REQUEST FOR WRITTEN APPROVAL TO USE CONSTRUCTION METHODS NOT INCLUDED IN OREGON ADMINISTRATIVE RULES 690-200 THROUGH 690-240

(2) Start Card Number(s): 119212

PERMIT # G-14762 WELL # MARI 2031

SEE ATTACHED DRAWING.

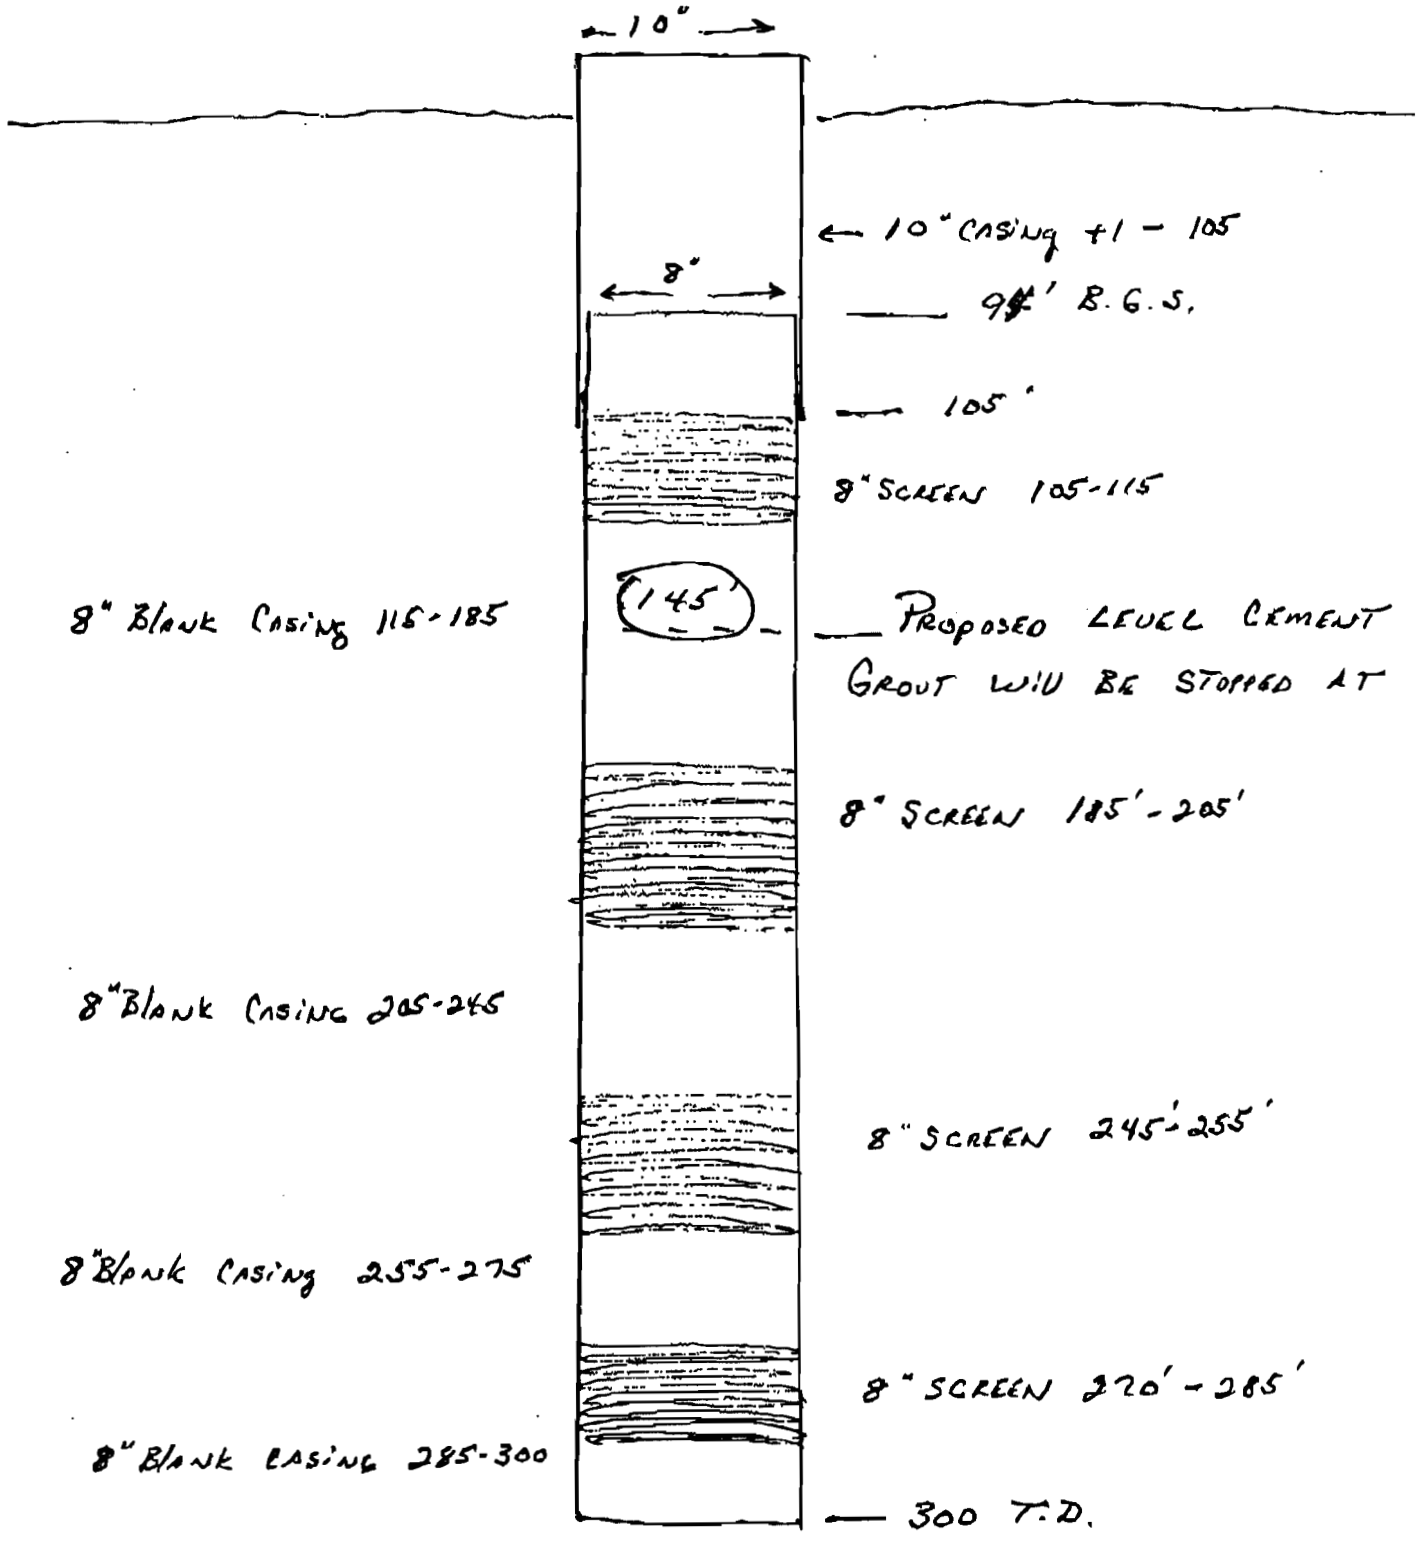
ABANDON LOWER PORTION OF EXISTING WELL BY

PUMPING CEMENT GROUT INTO BOREHOLE & OUT THRU.

EXISTING 8" SCREEN. CEMENT GROUT WILL BE PUMPED CONTINUOUSLY
UP TO 145 B.G.S. BECAUSE PERFORATING THE EXISTING 8" CASING
WILL CAUSE SCREEN ASSEMBLY TO PUSH OUT OF WELL,

It is Proposed To Add No More Perforations.

Approved by: *Michael M. East* Denied by: _____
